TO: PLANHOLDERS
ADDENDUM NUMBER THREE

DATE ISSUED: June 8, 2026

RE: Courthouse Restoration _ Phase 1 - Roof
Nuckolls County
150 South Main Street
Nelson, NE 68961

BERGGREN ARCHITECTS
PROJECT NO: 202503-503.1
NUMBER OF PAGES (Including Attachments): 8

ATTACHMENT C - NEW COPPER GUTTERS

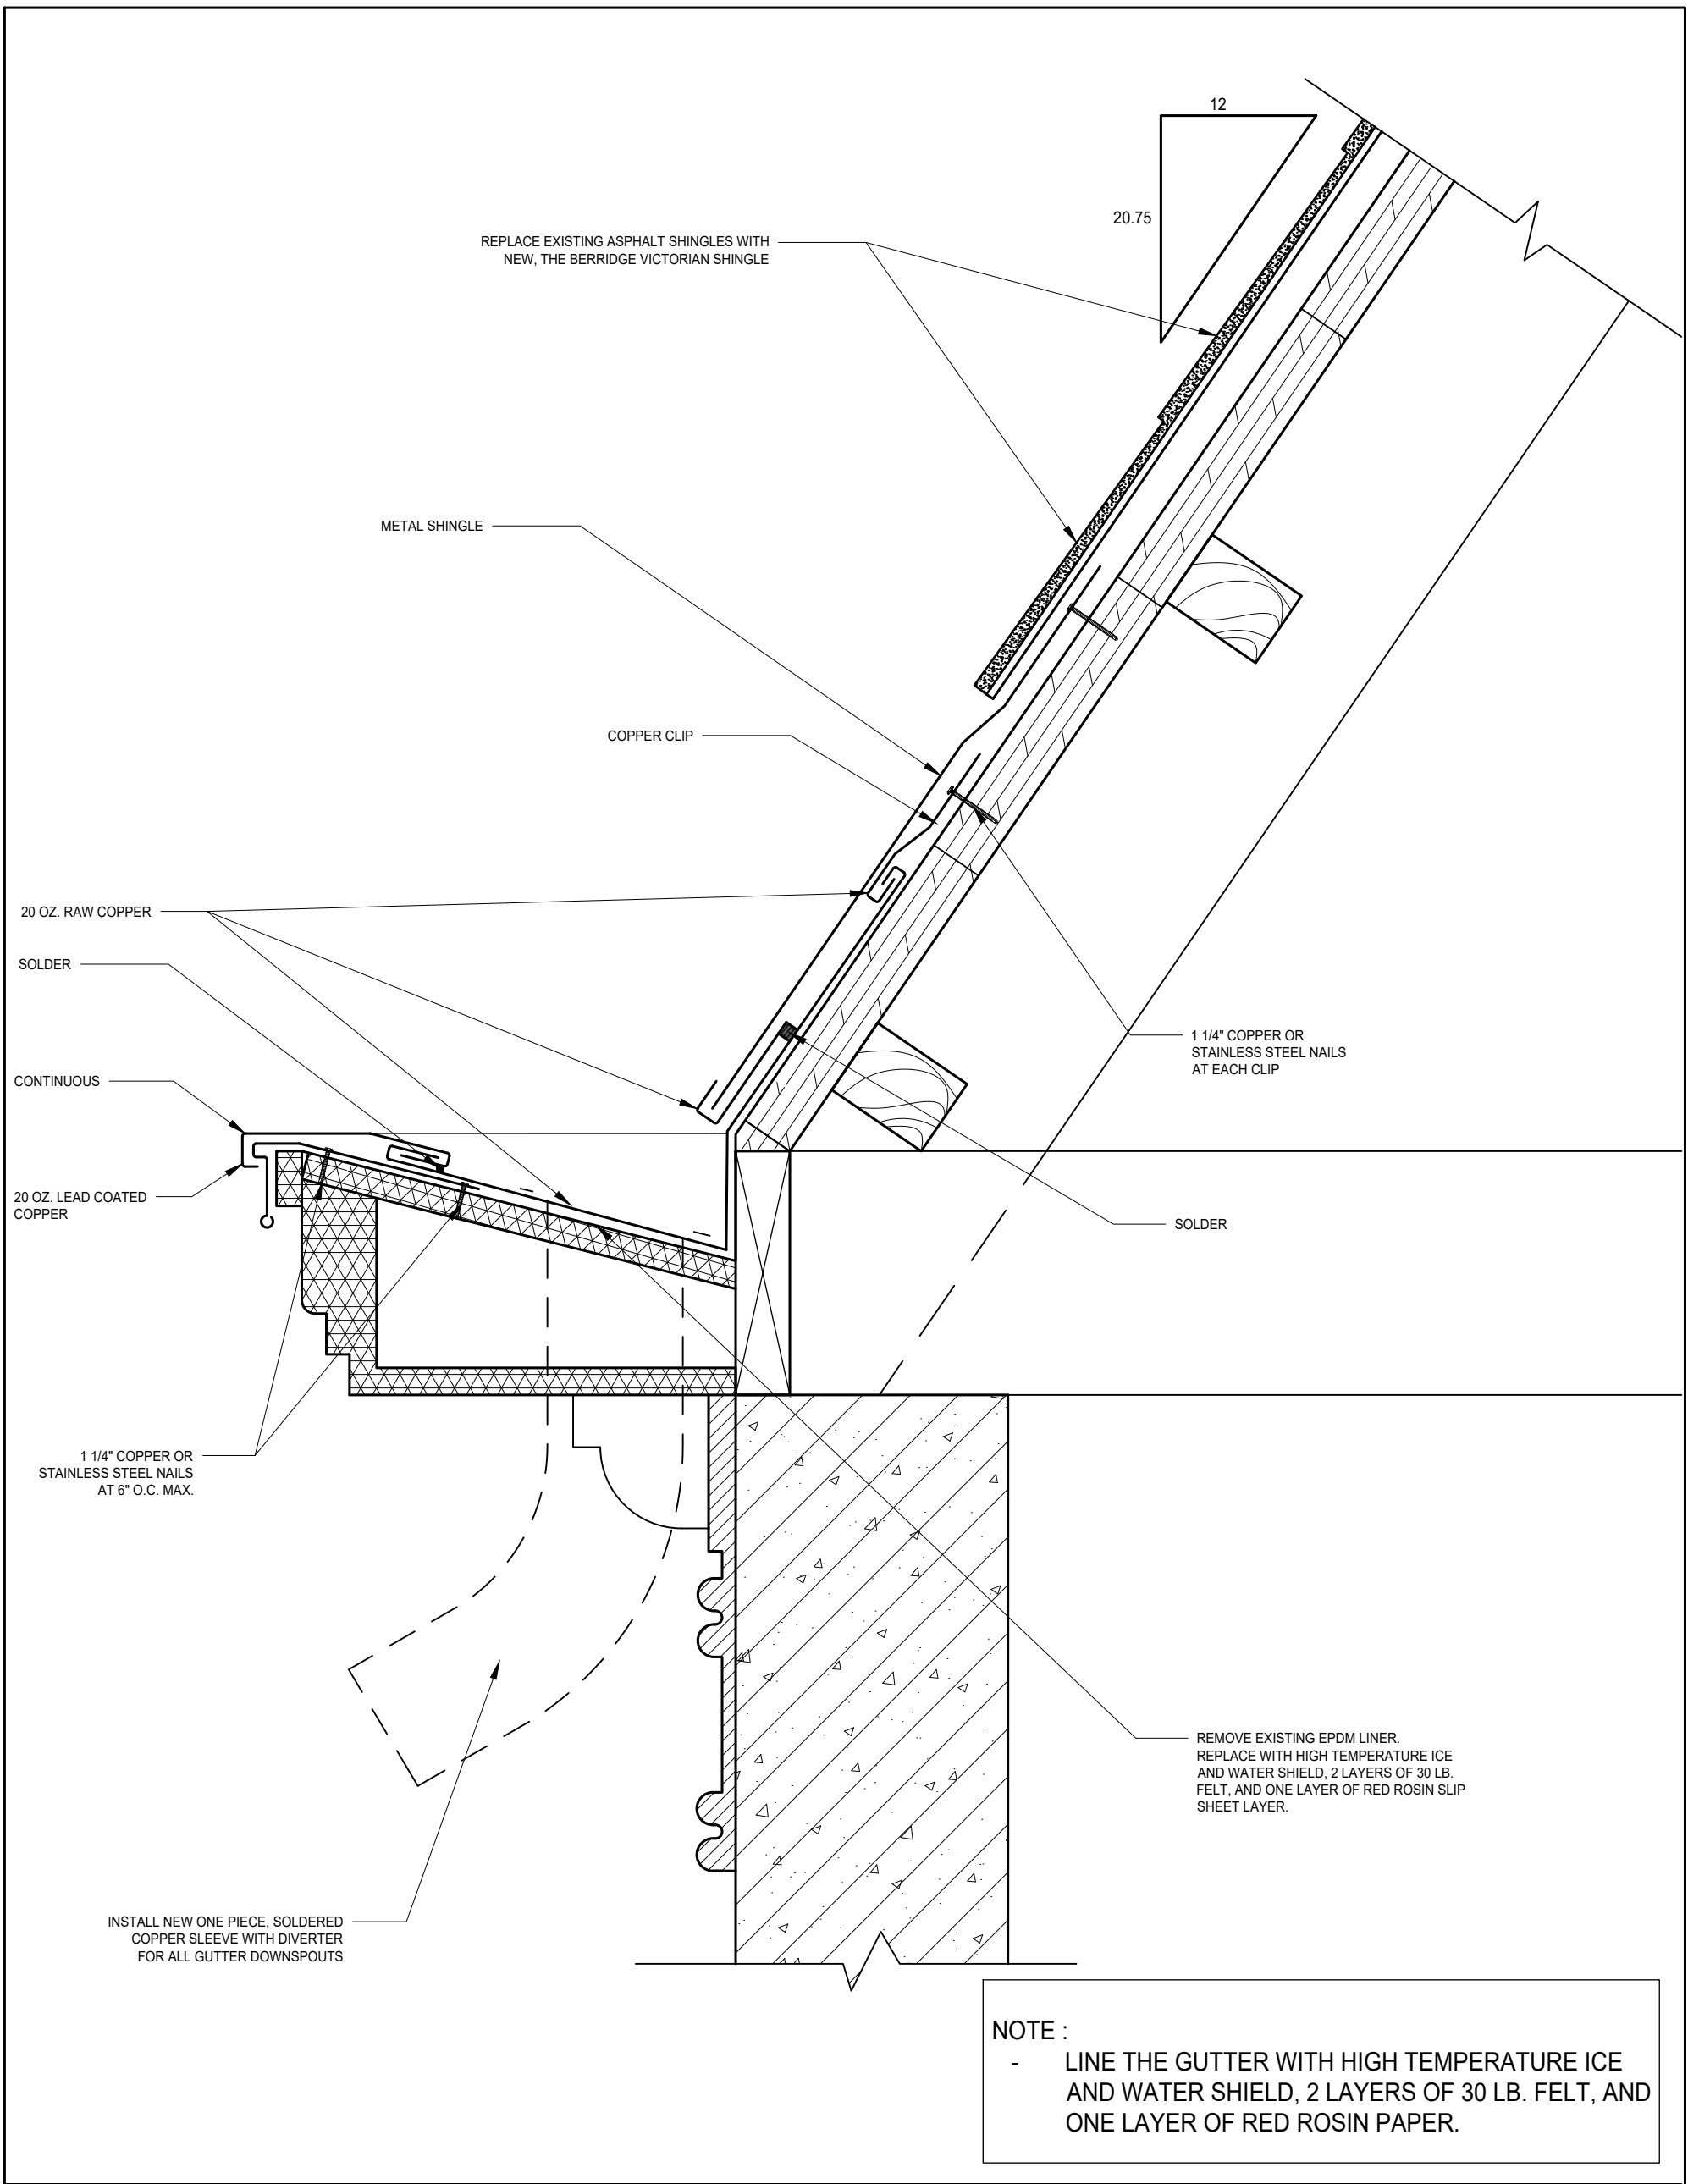
- A. Delete this sheet and refer to Attachment C for typical copper gutter lining detail. Provide positive drainage to the nearest downspout for each gutter run

- A. Delete this sheet and refer to Attachment C for typical copper gutter lining detail. Provide positive drainage to the nearest downspout for each gutter run.

- LINE THE GUTTER WITH HIGH TEMPERATURE ICE AND WATER SHIELD, 2 LAYERS OF 30 LB. FELT, AND ONE LAYER OF RED ROSIN PAPER.
